**City of Bellevue
Historic Preservation Commission
616 Poplar Street
Bellevue, KY 41073**

APPLICATION NUMBER: COA 26-007
APPLICANT: Leon Suarez
PROPERTY: 329 Berry Ave

PART 2 – COA REQUEST—COA 26-007

PART 1 – CONTRIBUTING OR NOT CONTRIBUTING

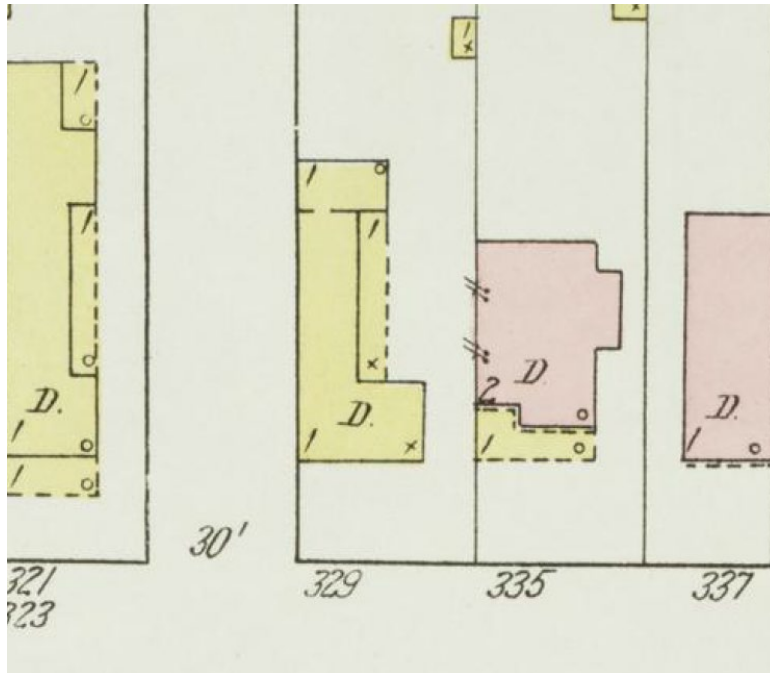
The house holds significant character as an early 1900's house as the scale, massing, setback, and most materials are intact. The presence of similar houses along this stretch of Fairfield Avenue as well as other areas of Bellevue gives a valuable reference for the original design and materials.

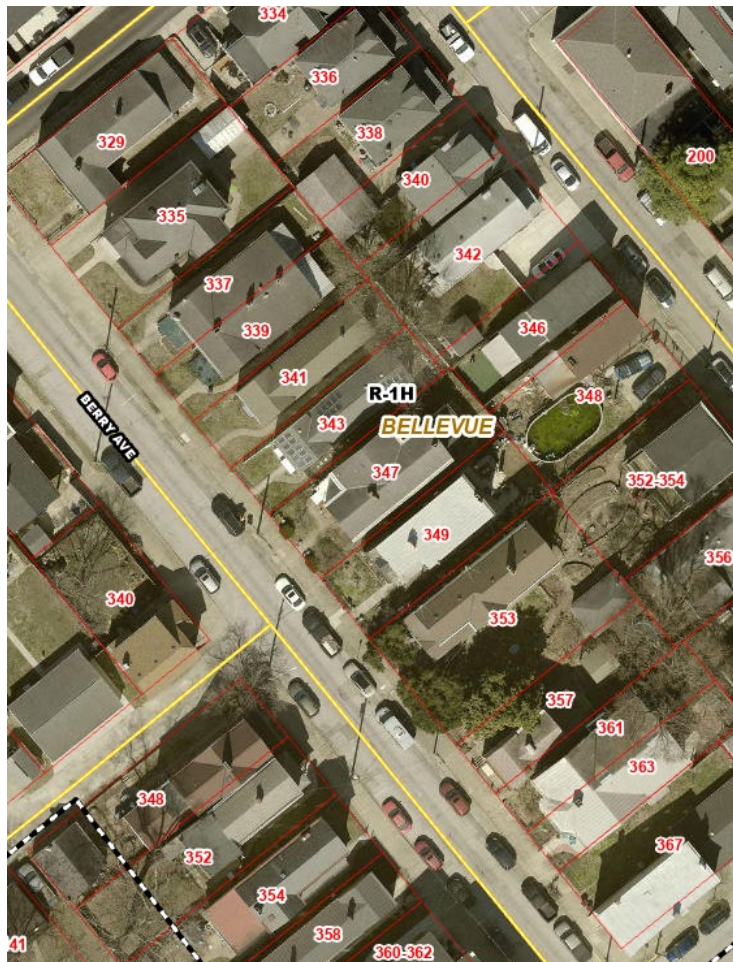
The historic entry stairs were simple concrete. It is not clear if they were in disrepair or if "significant deterioration" had occurred. It is also not clear if they remain beneath the new deck. The railing was wood.

The guidelines do not permit new decks to primary facades. 8.3.1.,d *"New decks shall not be added to a building's primary façade"*

Additionally, the deck encroached into the minimum front yard setback. In the R-1H zone, the minimum front yard depth is twenty (20) feet. The current setback is just under that at approximately 19 feet.

However, this does not include decks, porches or stoops.

In some cases, an automatic setback variance may be applied if other buildings along the block, and same side of the street also encroach. The average of those setbacks is then allowable. Unfortunately, the houses along this block are all about the same with an average setback of about 18 feet.

Staff does not have a remedy that would keep the new porch.

- The Historic guidelines do not permit new porches where there was no historic porch.
- The Zoning Ordinance requires building additions, including decks and porches to meet setback requirements. This porch appears to encroach approximately 8 or so feet into the front yard. Outside of the historic district, it may be possible to obtain a

variance to encroach into the front yard setback but the applicant would have to show significant hardship in being prevented from building the porch.
